CITY OF
West Linn
 PLANNING AND DEVELOPMENT

**STAFF REPORT
 PLANNING MANAGER DECISION**

FILE NO.: WAP-16-04

REQUEST: The applicant requires a Water Resource Area (WRA) for an addition to the existing house at 3979 Kenthorpe Way

FIGURE 2: Riparian Corridor/WRA Boundary superimposed on applicant's property

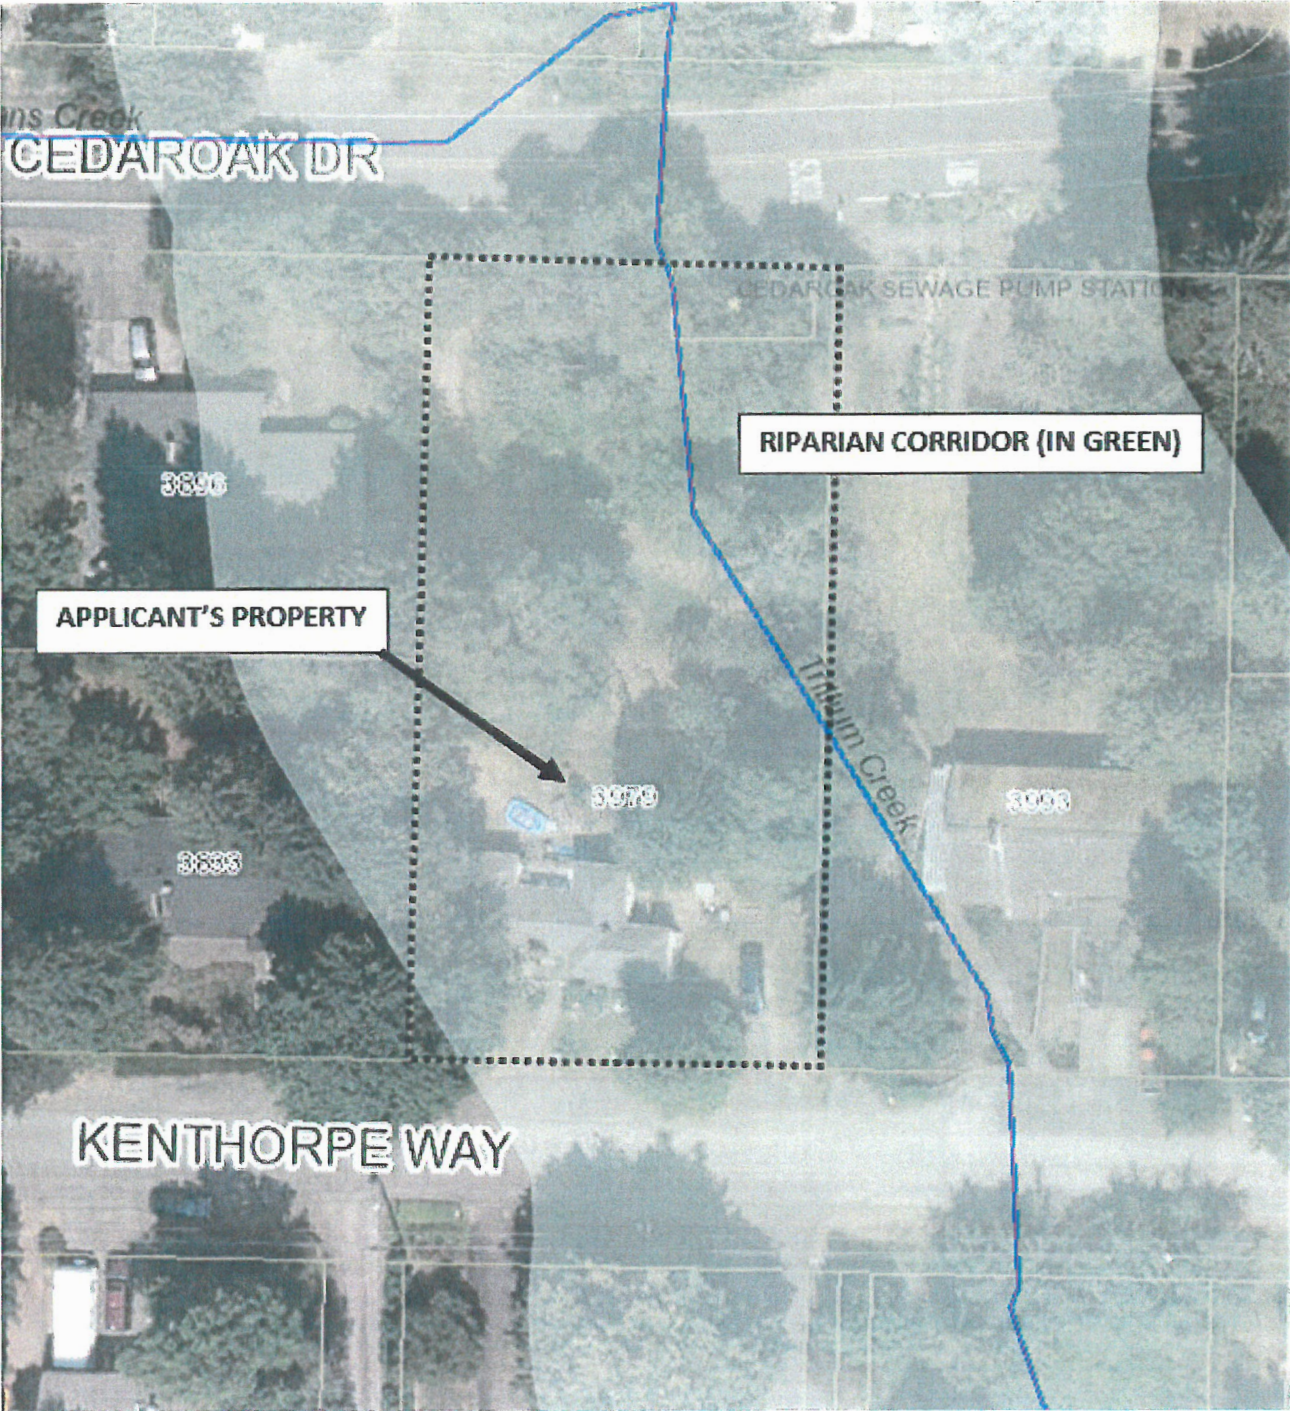
Trillium Creek is located on the east edge of the 3979 Kenthorpe Way property. The standard WRA boundary and Riparian Corridor extends onto, and encumbers, 99.5 percent of the property (see Figure 2). The property is also partially within a Habitat Conservation Area (HCA) (Chapter 28).

Staff Response 4: Trillium Creek is mapped as a Riparian Corridor with a 100 foot setback. The WRA width encompasses 99.5 percent of the property. Only a small 113 square foot area in the southwest corner is not within the WRA. By defining the WRA boundary/width, the criteria is met.

FIGURE 3: Habitat Conservation Area (HCA) Map

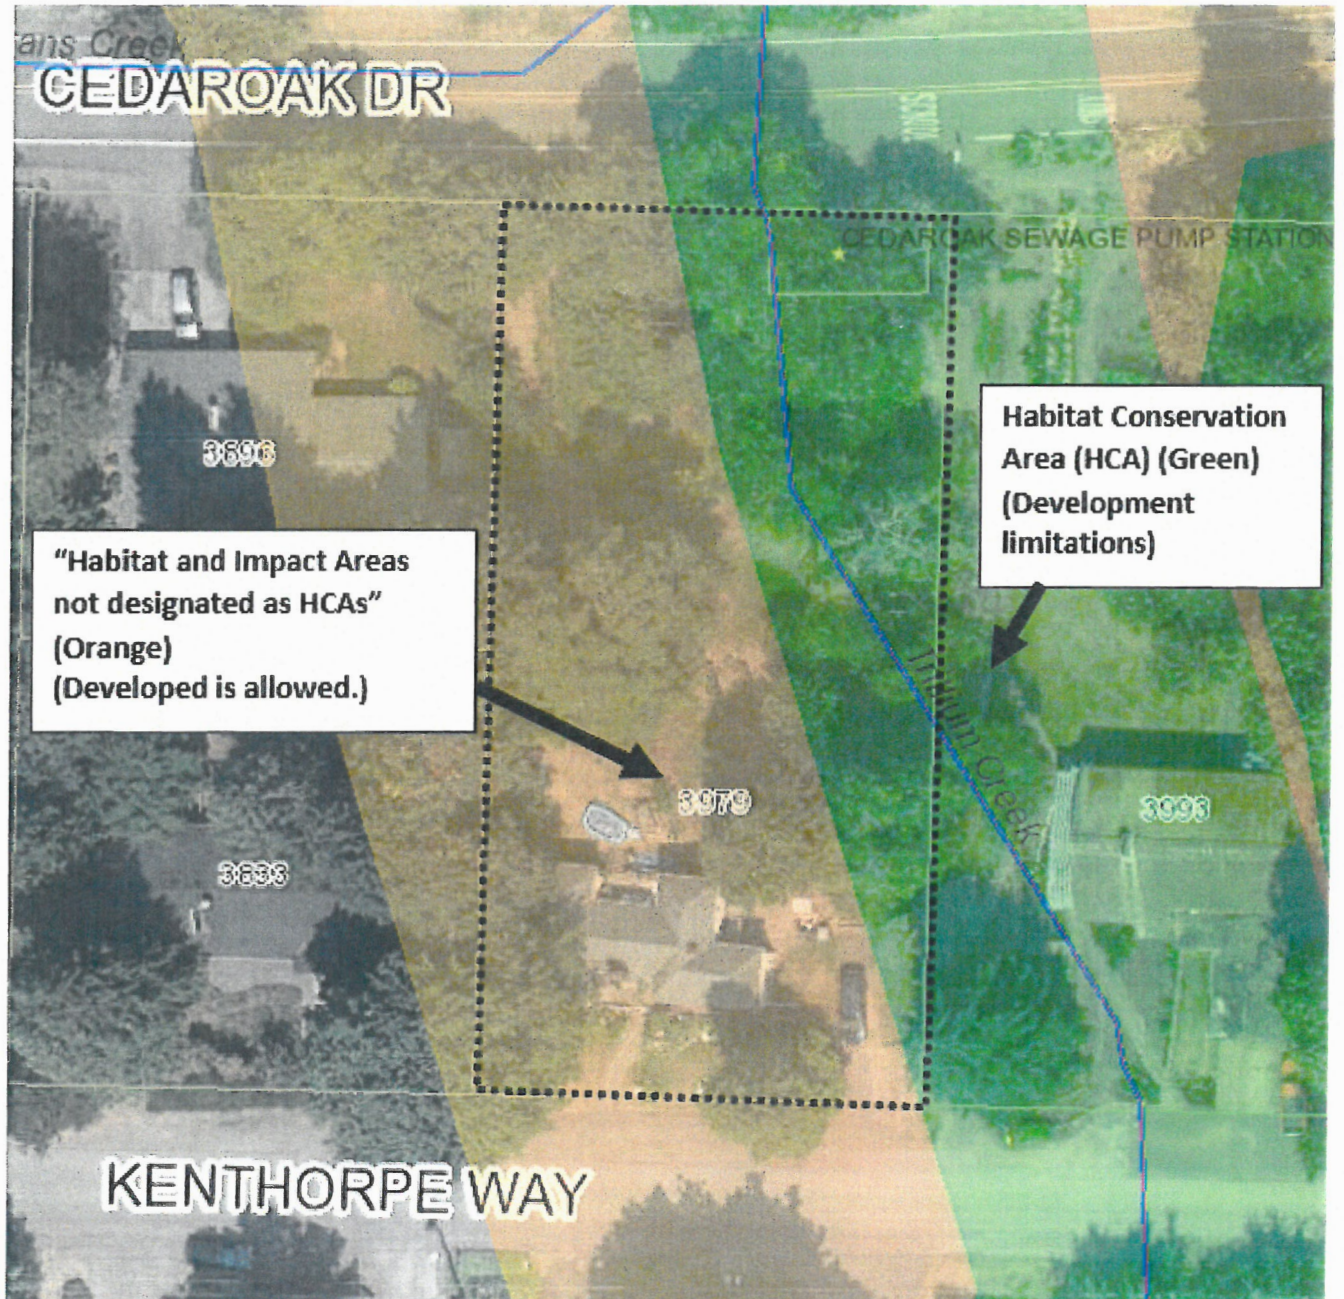
Staff Response 17: The east portion of the applicant's property has a "Habitat Conservation Area" (HCA) designation covering 6,648 square feet or 34 percent of the property. The majority of the west portion of the property has a "Development Allowed" designation. These HCA designations trigger review under CDC Chapter 28. This is a limited exemption subject to standards of 28.040 (S) (T) and (U).

In response to 28.040 (S), the eastern 10-15 feet of the proposed house expansion (comprising 225 square feet) including the pervious path on the east side of the house will be within the HCA. Therefore the application is not exempt per this criteria. The required development standards of the chapter apply; specifically, subsections (T) and (U) below.

FIGURE 4: Mitigation Plan (with staff comments in boxes)

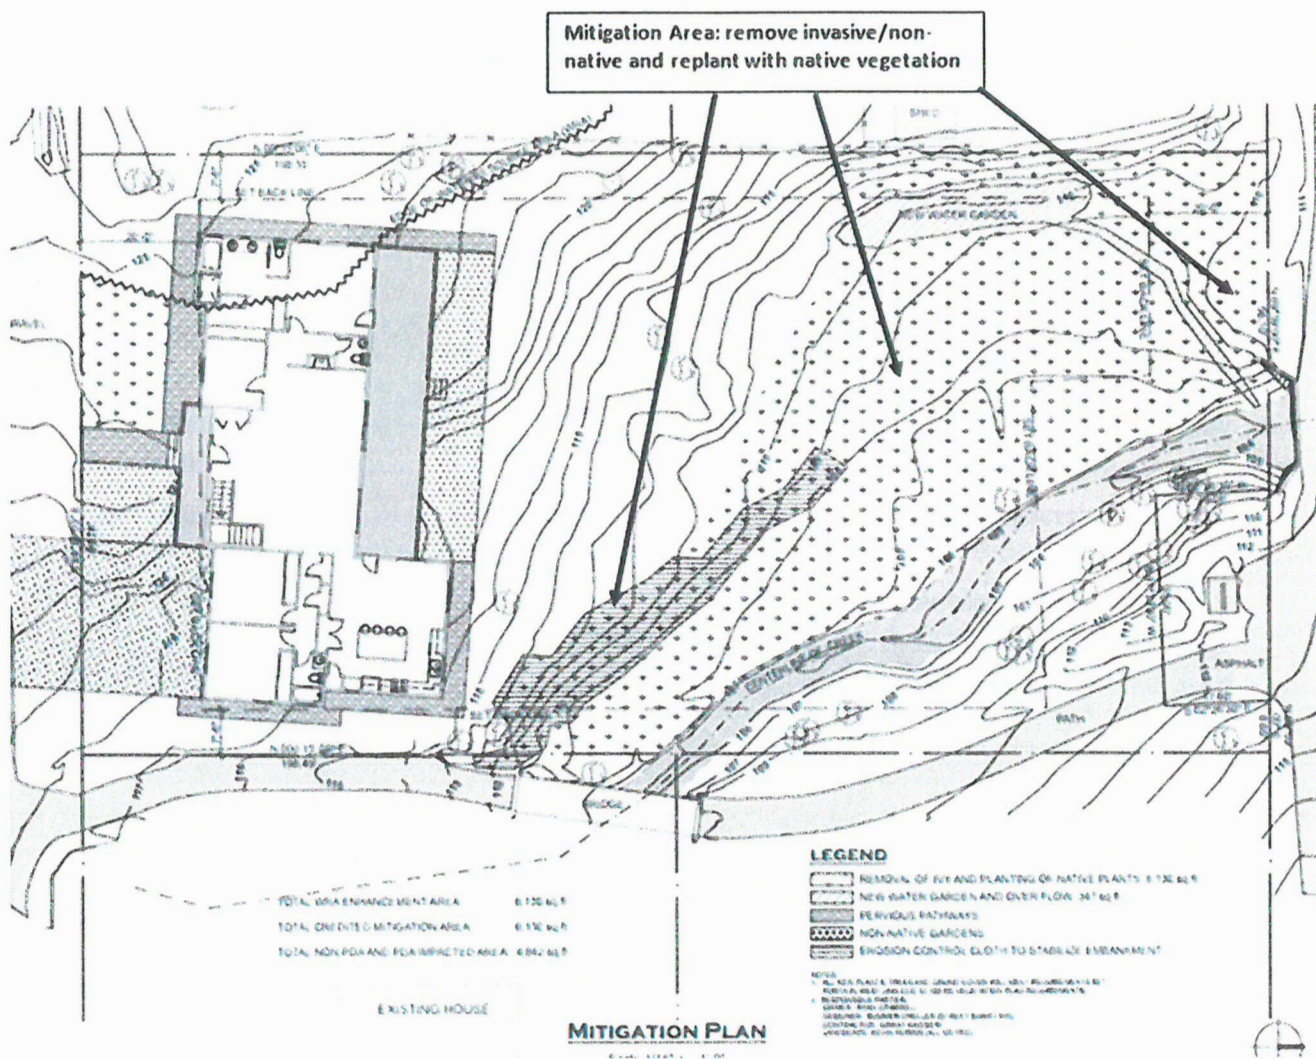
Staff Response 12: The applicant will provide on-site mitigation. The applicant’s “Mitigation Plan” on sheet A-0.5 of the applicant’s submittal involves removing invasive plant species,

mostly English Ivy, and planting 6,130 square feet of native plants in that area. By providing 1,288 square feet of additional mitigation beyond the required 4,842 square feet for the MDA/encroachment into the WRA, the applicant has met and exceeded the required “one for one” on-site mitigation requirement.

1. The applicant shall (a) remove the invasive groundcover and install native vegetative mitigation consistent the applicant's submittal and per CDC 32.100(A) (1-8) and (b) remove all existing development (shed, etc.) within the WRA. Both tasks (a and b) shall be completed prior to issuance of a building occupancy permit.

SHEET TITLE
WRA SUBMISSION MITIGATION PLAN

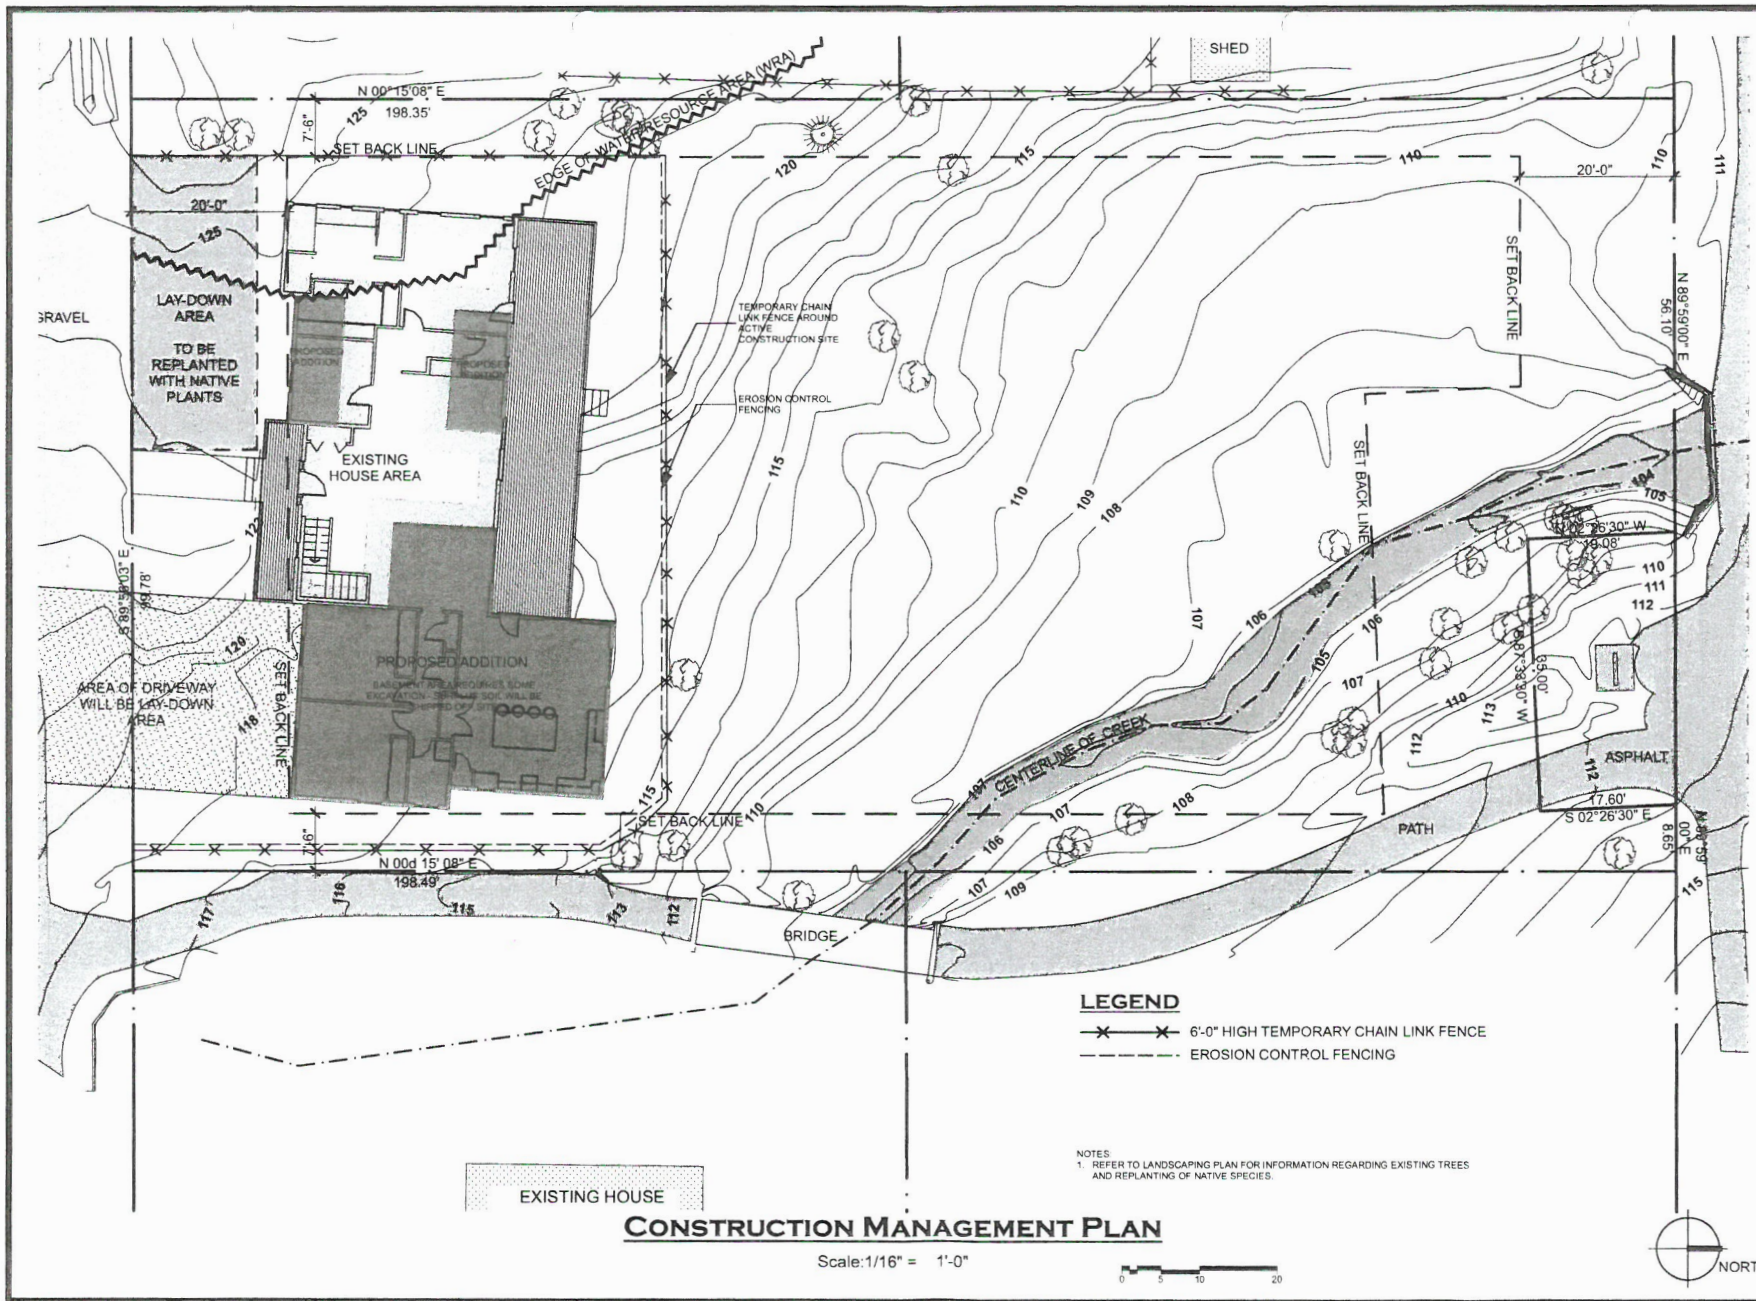
Staff Response 13: The applicant’s “Mitigation Plan” on sheet A-0.5 of the applicant’s submittal demonstrates compliance with the submittal requirements. The criteria is met.

Staff Response 14 The applicant's "Mitigation Plan" on sheet A-0.5 of the applicant's submittal demonstrates compliance with the submittal requirements. The criteria is met.
